Land north east of Junction 10 of the M42 Motorway / north of the A5, Dordon

**Sam Oxley CMLI on behalf of North
Warwickshire Borough Council**
**Landscape and Visual Effects, and
Consideration of Strategic Gap**

APP/R3705/W/24/3336295

Project Number
11883

Figure 3.2 A-A' Section

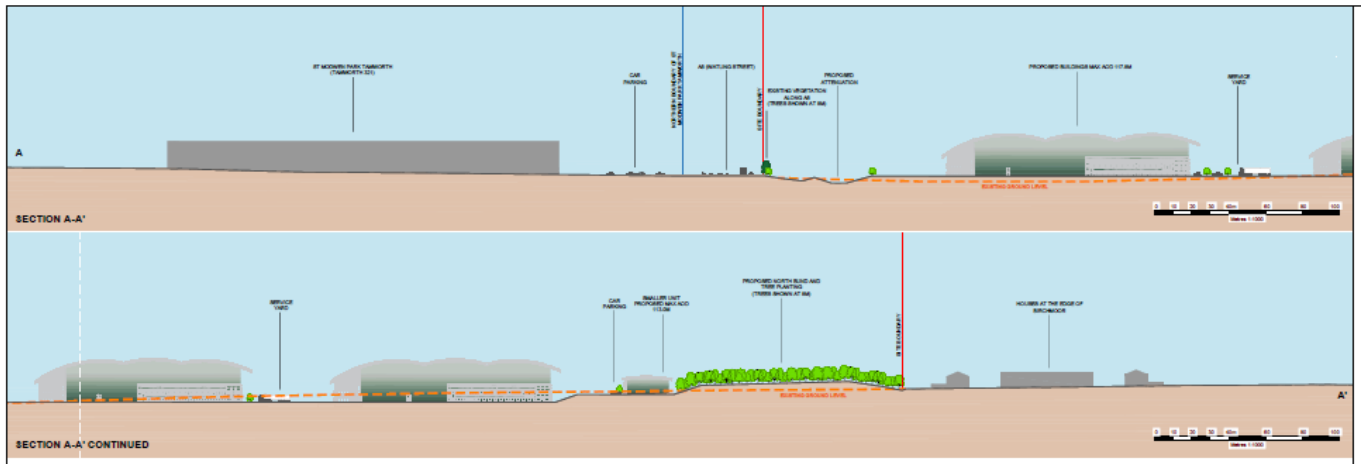
3.6 Cross sections across the site have been provided based on the indicative master plan. Section A-A' [CD-B30] provides a south-north cross section across the site (see Figure 3.2 below). It illustrates that the large building at the southern end of the site will sit at a level above the existing ground level, whilst the larger buildings in the middle and northern part of the site will sit at lower elevations compared to the existing ground level. The ground level will be stepped further north in the site, with the smallest unit sat higher up compared to the others. Although the ground level of this unit will be higher, it will still sit below the existing ground level, and the height of the building itself will be lower than the larger units. The cross sections appear to show buildings that are over 21m height (as measured with a scale ruler, so approximate), and certainly quite a lot higher than those at St Modwen Park, which seems to match the height of the lower gullies between the proposed roof domes. The domes appear to be more like 25m high, with the roof line at St Modwen being closer to 20m high. It is not clear if this is what is being proposed, or if the ground level will be brought up. The labelling indicates a maximum AOD of 117.8m.

3.7 The proposed tree planting between the buildings and Birchmoor will be on bunding which sits at a higher level than the current ground level of the site. In the Landscape SoCG it was agreed the bunding would not exceed 5m in height. This bunding will be tapered. A separation distance indicates as being

c.15m will be maintained between the bunding/ woodland and between the gardens of Birchmoor, as shown on Section A-A'. This area currently contains paddocks. Consideration - through relevant technical lighting studies - should be given to the potential loss of light on the properties at Birchmoor as a result of tree planting on the bunding, especially in conditions of a low winter sun. The bund is shown as 5m high, and the trees at 8m high, although in time they would grow to more than this. The bund and trees together would be at or exceed the height of the houses, as the section indicates.

Figure 3.3 Sections B-B', C-C' and D-D'

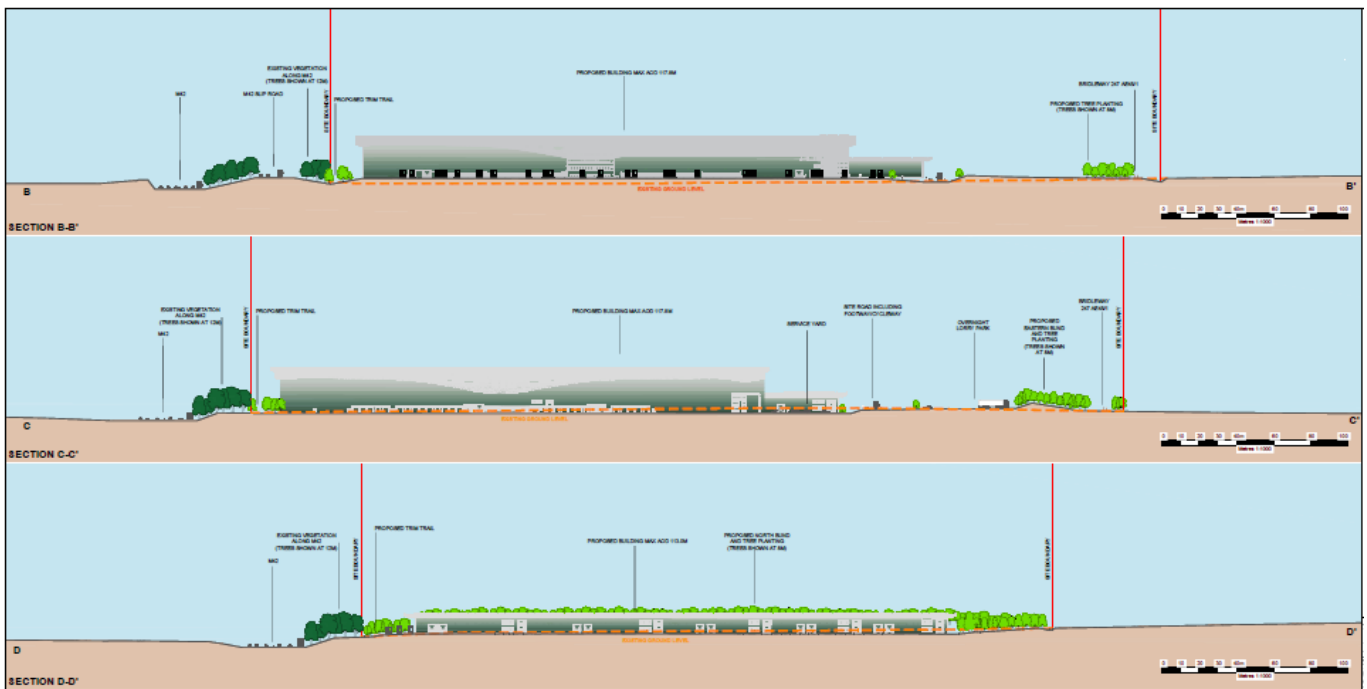
3.8 Sections B-B', C-C' and D-D' [CD-B30] provide a west-east cross section at the southern, middle and northern parts of the site (see Figure 3.3 below). Bunding as shown in the C-C' cross-section of the site appears to be quite high and steep compared to the northern and southern sections. Space here will be constrained by the proposed re-routeing of the bridleway, which the Design and Access Statement indicates as crossing over the bund (Design and Access Statement Figure 69). Gradients may not allow for this in practice.

Figure 3.4 Illustrative landscape bund section – noting the suggestion that it is angular and very densely planted

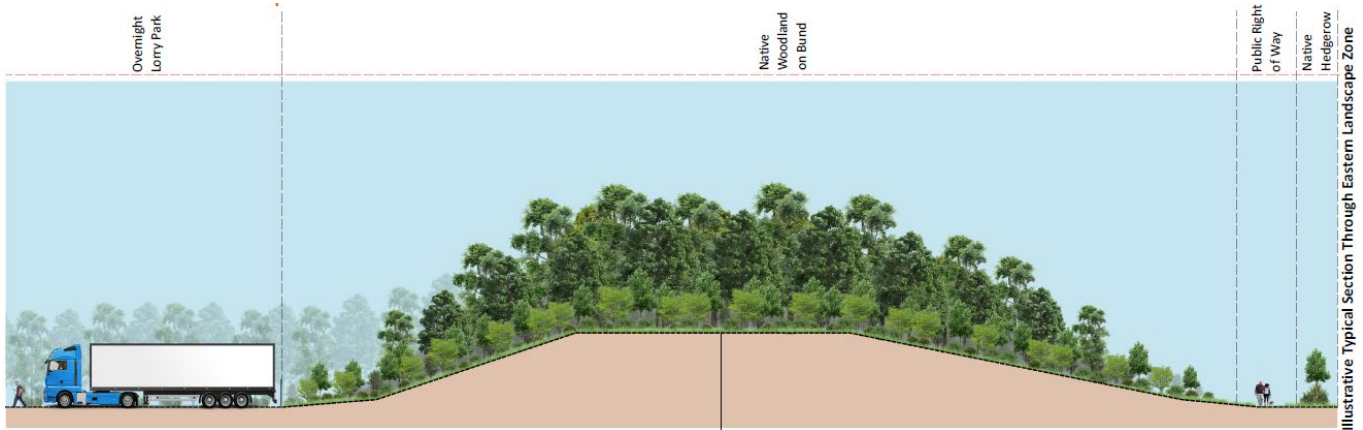
Landscape SoCG that they would not exceed 5m high, but the exact nature of the proposals is somewhat uncertain. The scale of these mounds is illustrated in the cross-section provided in Section 4.3 of the Design Guide [CD-B11 and CD-B35] (see Figure 3.4 below). Whilst the appellant describes these bunds as '*naturalistic*' with '*soft slopes...to replicate a natural environment*', I consider that the bunds would be of a large scale which are not sympathetic to the shape of the surrounding, gently undulating semi-rural landscape. They would in themselves block views, and potentially sunlight (would need to be demonstrated through appropriate technical studies) from downstairs windows, and together with planting, and the development which would lie beyond, are also likely to block views from the upstairs windows in Birchmoor.

3.31 Planting on the east edge is described as '*densely planted*' in the LVIA (page 153 of 223), and as a heavy landscape buffer in the Design and Access Statement. This is not elaborated upon, but woodland that is densely planted tends to have an unnatural appearance, and without management could develop into a dense and rather spindly thicket, of lower landscape and aesthetic value than that with a spacing which allows trees to develop into natural forms, or with open glades between them.

Figure 3.5 Junction Access – note that the hedgerows are indicated on the lower drawings indicating that they will need to be removed

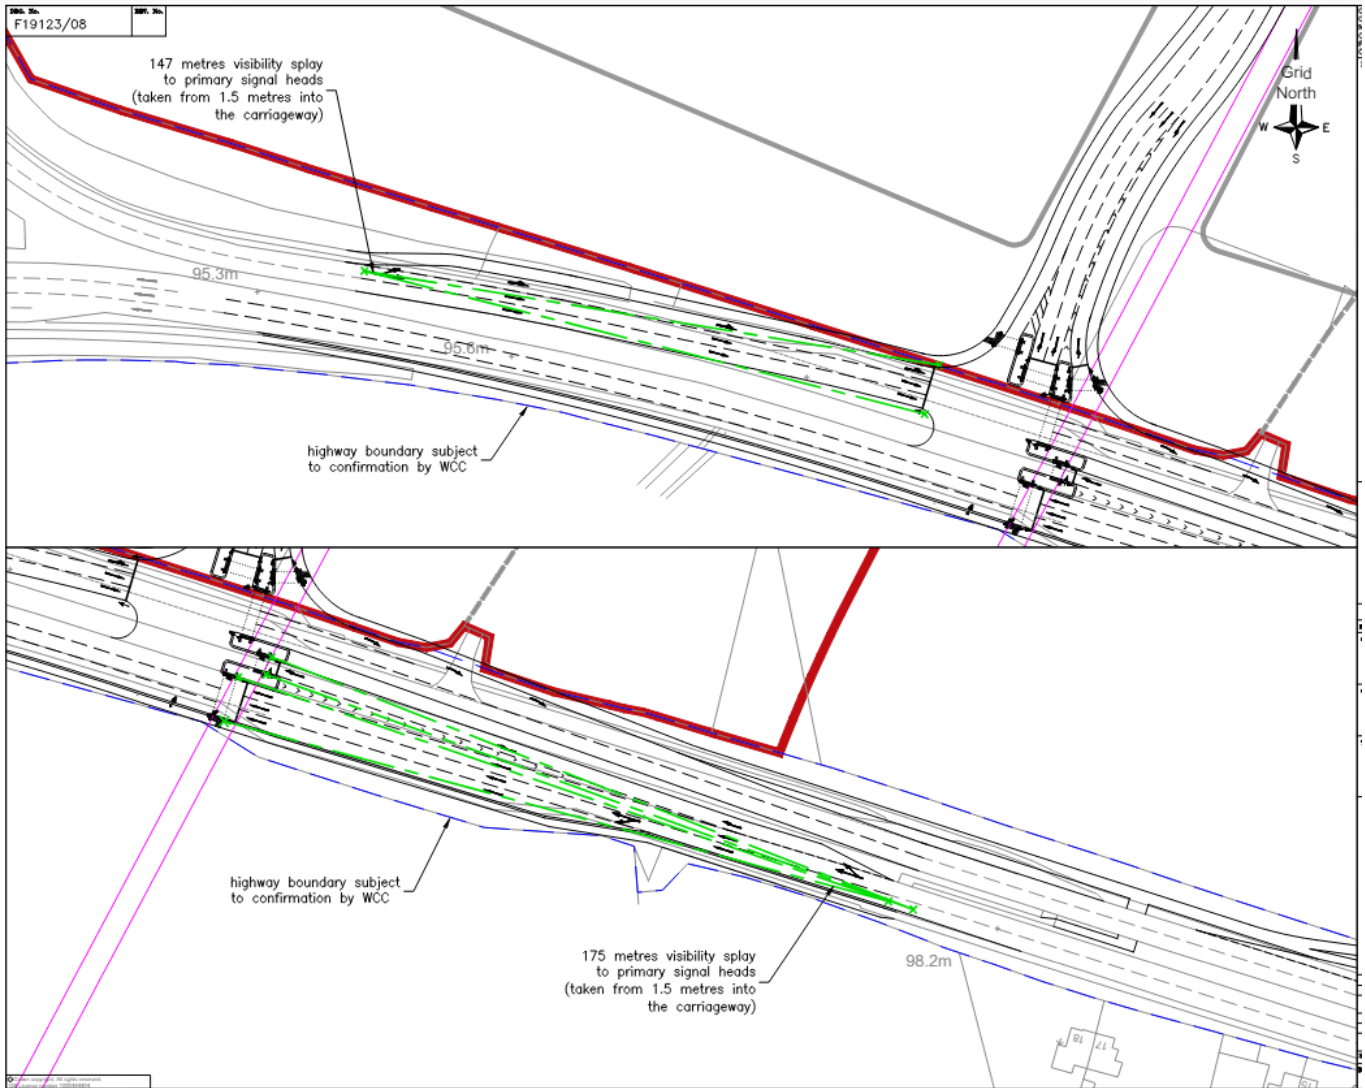
3.51 However, I have concerns about how much of the existing hedgerow would actually be retained in practice. As illustrated in Drawing F19123/08 within Appendix 6.1 – Transport Assessment [CD-A9.2] (see Figure 3.5 below), a 147m long visibility splay along the eastbound deceleration lane will be required (west of the access junction). It is not clear what the visibility splay to the east of the junction would be, but it appears the road will be widened here to allow for lorries to exit and travel eastbound. Assuming a similar length, over 300m of hedgerow is likely to be affected, as well as further lengths of hedgerow and tree belts to accommodate widening and regrading at the roundabout to the west, and to allow for cycle land infrastructure to the east. This will open up visibility of the site from the A5 more widely. In addition, it appears a c.175m long visibility splay could be required on the westbound side of the carriageway, which could result in loss of hedgerows to the south. The effects seem uncertain here, but would appear to be understated by the appellant.

Figure 4.1 Strategic Gap commentary

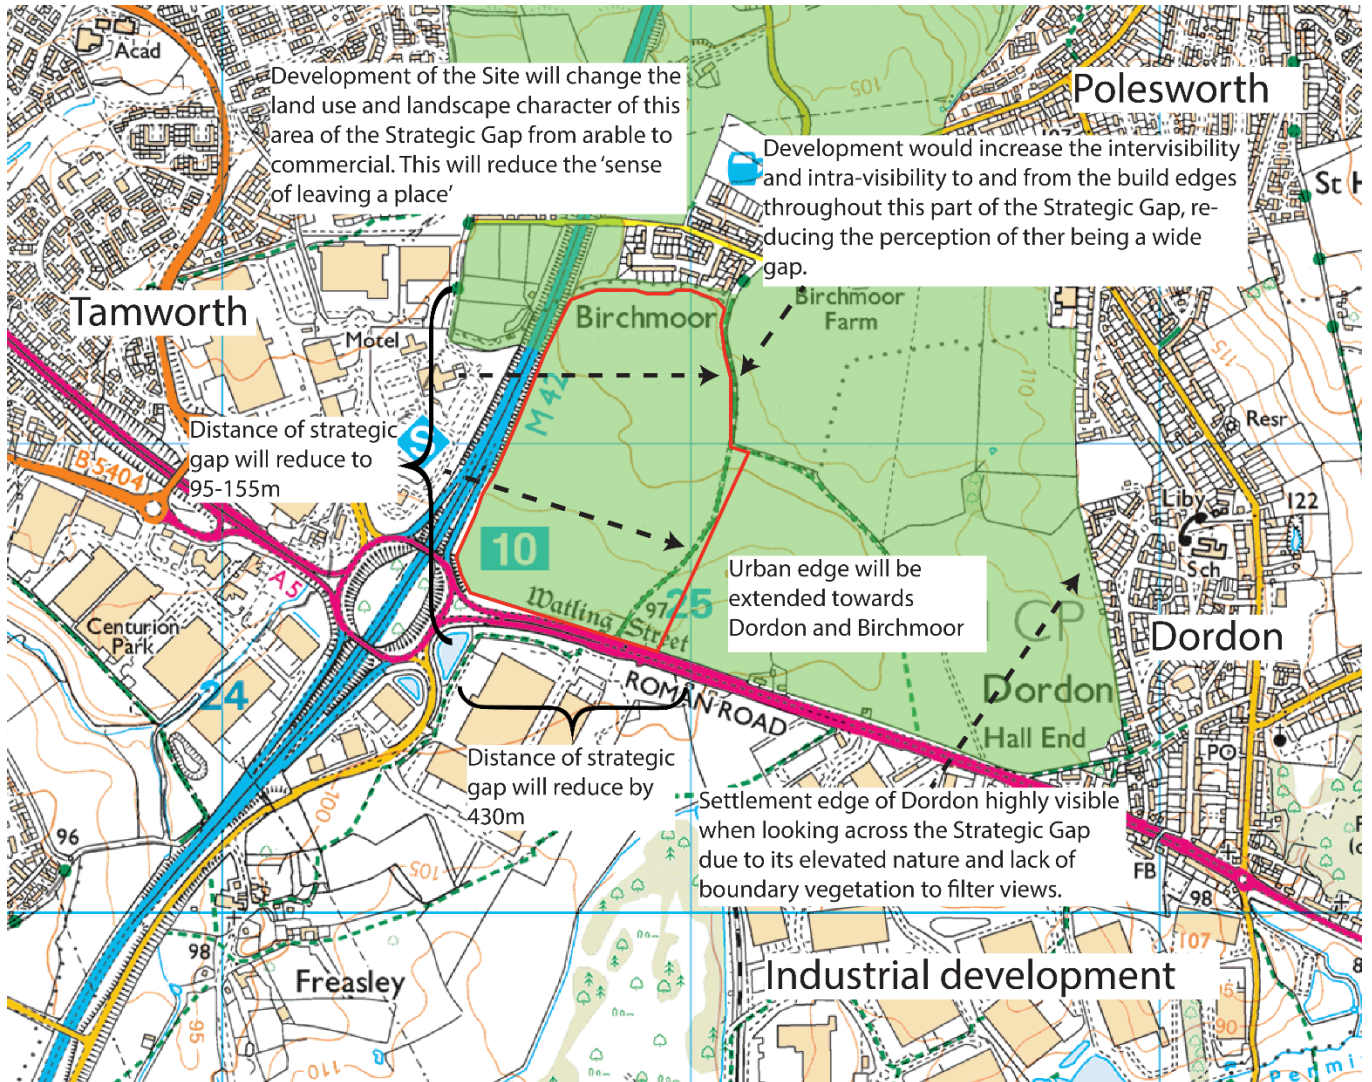
4.11 Table 4.1 below sets out the Eastleigh Criteria, with comments provided on how the proposal will affect the Strategic Gap provided. The effects on the Strategic Gap, with relation to the Eastleigh Criteria are illustrated in Figure 4.1.

Eastleigh Criteria	LUC Comment
	<p>Tamworth, and vice versa to Dordon. This allows the clear separation of these settlements by arable land to be appreciated.</p> <p>The proposed development will in some senses reduce this intervisibility, by screening views across the Strategic Gap, due to the large buildings, bunds and planting. Intervisibility between the <u>new</u> edges would increase however, given the substantial narrowing of the gap between the edges, making them closer together.</p>
<p>Intra-visibility (the ability to see both edges from a single point)</p>	<p>The open and flat nature of the site and Strategic Gap enables intra-visibility from across the site and the open land which surrounds it.</p> <p>From the A5 and the network of PRowS to the north of the road, eastward views focus on the open views across the Strategic Gap to Dordon's western edge. Given the elevated nature of Dordon and the lack of vegetation along the edge to filter visibility, the western edge of Dordon is a clear feature in these views. The eye is drawn more to the north-east, towards Dordon, than to the developments on the southern side of the A5. This is due to the openness of the landscape and the views available across it. Likewise, the eastern edge of Tamworth is visible in views to the north-west from sections of the A5 and extensively from the network of PRowS to the north of the A5. This is due to the open nature of the fields across which the site is located, and the gaps in hedgerow along the road. The visibility of both the eastern and western settlement edges, across an arable landscape, allows the clear separation of these settlements to be appreciated when in this area.</p> <p>The proposed development will reduce this intra-visibility by screening views from within the Strategic Gap to the former development edge to the west. This is given it will block views with large buildings, bunding and planting. However, it will also increase intra-visibility to the <u>new</u> edge, given the substantial narrowing of the gap between the edges, and the much closer proximity of the development to the gap.</p>

Eastleigh Criteria	LUC Comment
The sense of leaving a place	<p>Currently, there is a distinct sense of leaving the surrounding areas (Tamworth, Birchmoor, Dordon and the commercial area to the south of the site) when entering the Strategic Gap area. The Strategic Gap contrasts strongly with the surrounding built development due to its open, agricultural landscape.</p> <p>The settlement edge of Dordon is a clear feature in north-easterly views when travelling along the A5. Likewise, the eastern edge of Tamworth is noticeable in westerly views from this main road. When travelling in both directions, the settlement edges are seen in the distance, filtered by hedgerows on the north side of the road which have been left to grow tall, behind gently rolling fields to the north of the A5. This helps to ensure there is a sense of separation between Dordon and Tamworth when travelling along the A5 Watling Street (Roman Road).</p> <p>The proposed development would diminish the sense of leaving a place by changing the land use and character of the Strategic Gap. This would be achieved due to extending built development across the Strategic Gap between Birchmoor and the commercial development to the south, and Tamworth and Polesworth. The removal of woodland belts and hedgerows on the north side of Watling Street, between the roundabout and east of the proposed site access, to allow safe access into the site, will contribute to the perceived extension of Tamworth eastwards, through the resulting suburbanising influence.</p>
